Technical Booklet

LG Electronics Alabama, Inc.
2023. 09

Service Bulletin

Air Filter Cover part change for Standardization

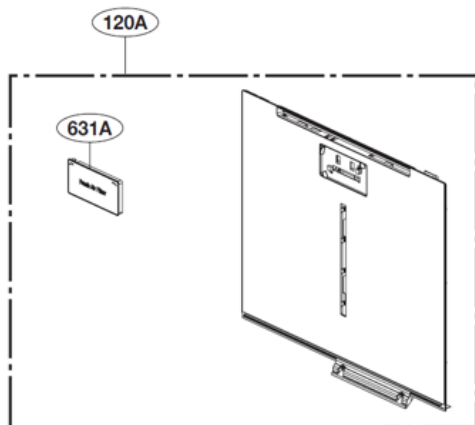
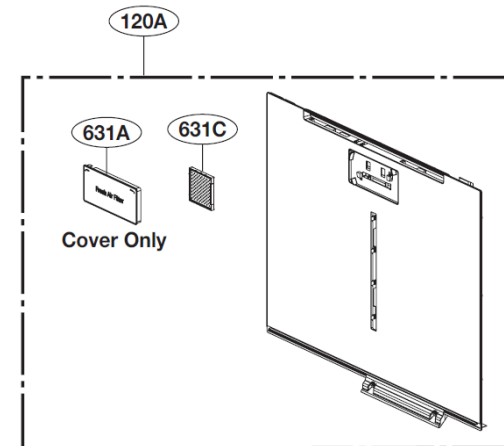
<p>Symptoms</p>	<p>Air Filter (LT120F) does not fit into the air filter cover</p>	<p>Picture</p>	<p><u>Front View (Same)</u></p> 	<p><u>Back View</u></p> <p>As Is Slanted</p>  	<p>To Be Square</p>  
<p>Cause</p>	<p>Air Filter Standardization Affected parts : Air filter cover, Duct assembly</p>

No	SVC Location	Description	Part Number		Remark
			Current	New	
1	631A	Filter Assembly,Air Cleaner	ADQ75493310	ADQ75493321 Cover only	Changes
2	631C	Filter Assembly,Air Cleaner	None	ADQ73214408 Filter only (LT120F)	Add

1. Replace with the new parts
2. Current and New (Visual / Part number & Name etc)

Conversion Kit

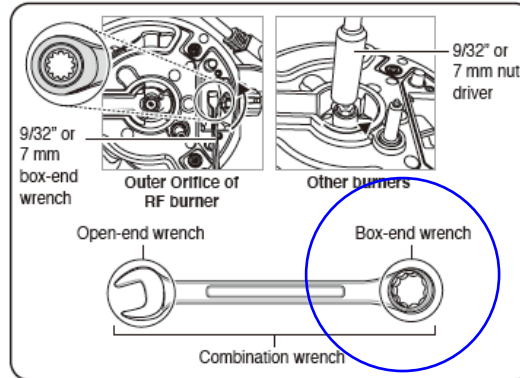
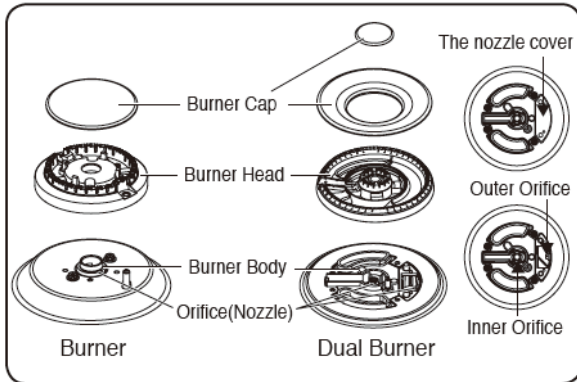
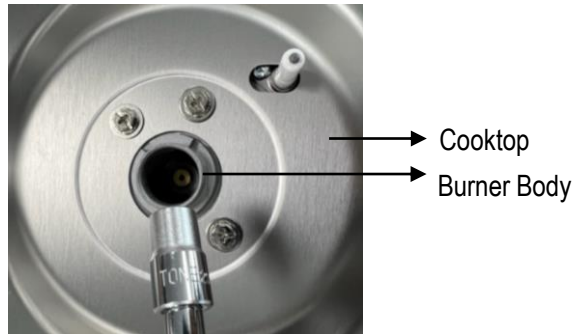
1) To convert the Outer Orifice of the Dual Burner, using a 9/32" or 7mm box-end wrench. (The 6 point box-end wrench is recommended.)

※ When using an open-end wrench, the nozzle may be damaged or deformed as 'Defect Case' below, so use a box-end wrench.

When Converting the Gas, proceed according to the contents of 'CONVERSION KITS'.
 Also, Please be sure to check the following 'Note' below.

OK

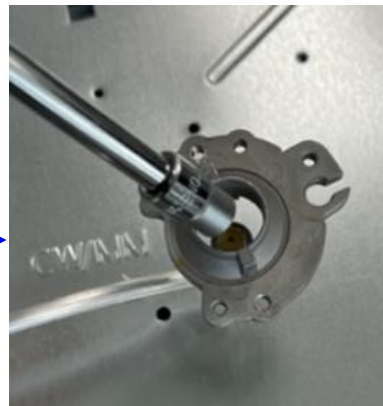
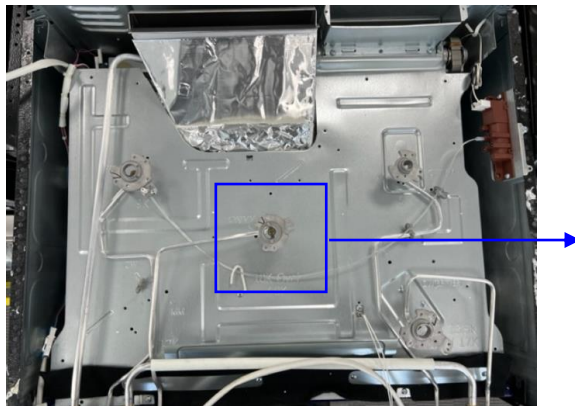
2) When removing the orifices, proceed with the burner body fixed to the cooktop with screws.

NG ※ Do not remove the orifices when the cooktop is removed or the burner body is not secured.
(The pipe may be damaged as shown in the 'Defect Case' below.)
